DRAFT CONDITIONS OF DEVELOPMENT CONSENT
Development Application No. DA15/0742

PART 1 - DEFERRED COMMENCEMENT CONDITIONS

Figure 1: Eastern elevation of Block A showing extent of non-compliance (height plane dashed in purple)

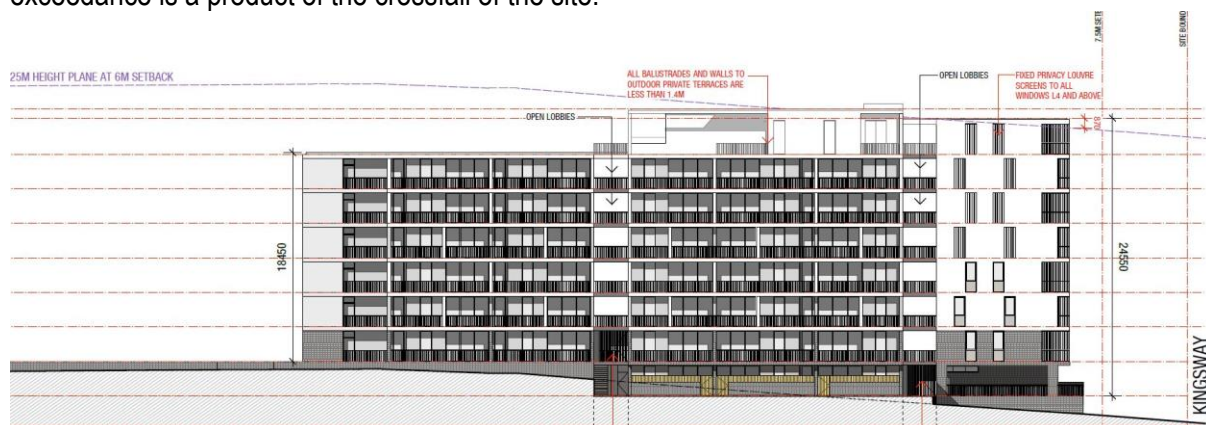
The Development Application as lodged involved a height breach of a maximum of 2070mm at the north eastern corner of Block A and 1910mm at the south western corner of Block B. The amended plans, as now submitted include a reduction in the height of the proposed buildings. The development as now proposed involves a minor height breach of 870mm which occurs at the north eastern corner of Block A and a breach of 710mm on Block B which occurs at the south western corner. As indicated in the elevations included in Figures 1 and 2 below, the encroachments relate to the proposed roof slabs and the lift overruns on the northern portion of Block A and the southern portion of Block B. Furthermore, the northern elevation of Block A and the southern elevation of Block B are provided in Figures 3 and 4, respectively. Figures 3 and 4 clearly demonstrate the minor extent of the exceedance with the datum taken as compliant at one corner and then the elevation climbs to a non-compliance. That is, the datum exceedance is a product of the crossfall of the site.

- i) The entire development must have a maximum building height of 25 metres above existing ground level at any point on the site, based on the surveyed levels on the survey plan titled "Plan of Detail and Level at No.2-22 University Road Miranda" Issue No. 4, dated 19 October 2015 and prepared by Linker Surveying. This reduction in overall height must be achieved by dropping the entire building (including basement levels and podium) by 800mm, i.e. 800mm deeper excavation.
